Independent Environmental Audit 2021

Centennial Airly Mine

May 2021

Figure 1 ARP04 Calibration Hydrograph – Modelled vs Observed Groundwater Levels (GHD, 2019)

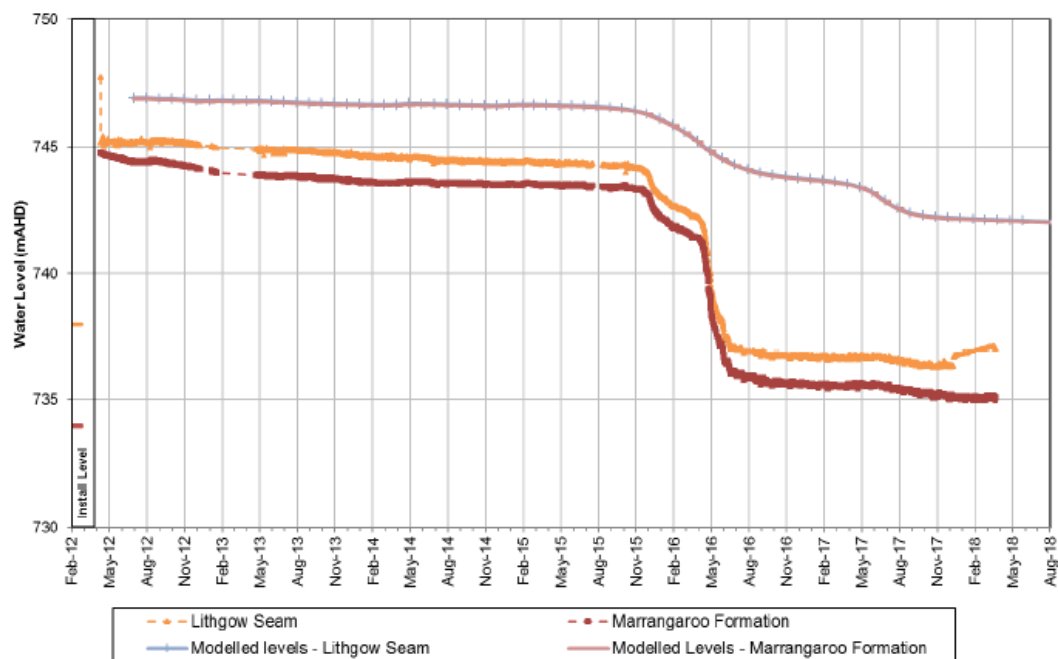
Mining related depressurisation is noted at ARP04, and ARP05. The mining impact is definite at site ARP04 and probable at ARP05. As shown in **Figure 1**, The calibration hydrograph for ARP04 was included in the recent model recalibration report (GHD, 2019). **Figure 1** shows the groundwater model predicts higher groundwater levels at ARP04 than observed, but under predicts the magnitude of the response to mining compared to observations.

The groundwater model recalibration did not include ARP05. Therefore, the comparison between observed and simulated groundwater levels was not possible. The 2020 annual water monitoring report (GHD 2021) noted that groundwater levels at the standpipe ARP08 were significantly higher in 2020. Electrical conductivity also displayed an increasing trend during 2020. The standpipe ARP08 is installed in the Lithgow Seam. Like ARP05, ARP08 was not included in the model recalibration. Therefore, it is unknown how the model is simulating the groundwater levels at ARP08. No reason was given in GHD (2019) report as why some of the VVPs and standpipes were excluded from the recalibration.

As shown in **Figure 1**, the recalibration hydrograph for ARP04 in the Marrangaroo Formation and the Lithgow seam shows the model over predicts the groundwater levels by approximately 7 m at the end of the recalibration period (August 2018). The simulated depressurisation for ARP04 was approximately 5m while actual observed depressurisation is of the order of 9m at the end of the recalibration period. One possible reason for the difference in the simulated and observed depressurisation is that the actual base of the Lithgow seam is lower than the elevation of the model layer representing the Lithgow seam in the model.

It is recommended that the simulated groundwater levels at the VVPs and standpipes excluded from the recalibration should be extracted from the model and be used to compare against the groundwater measurements.
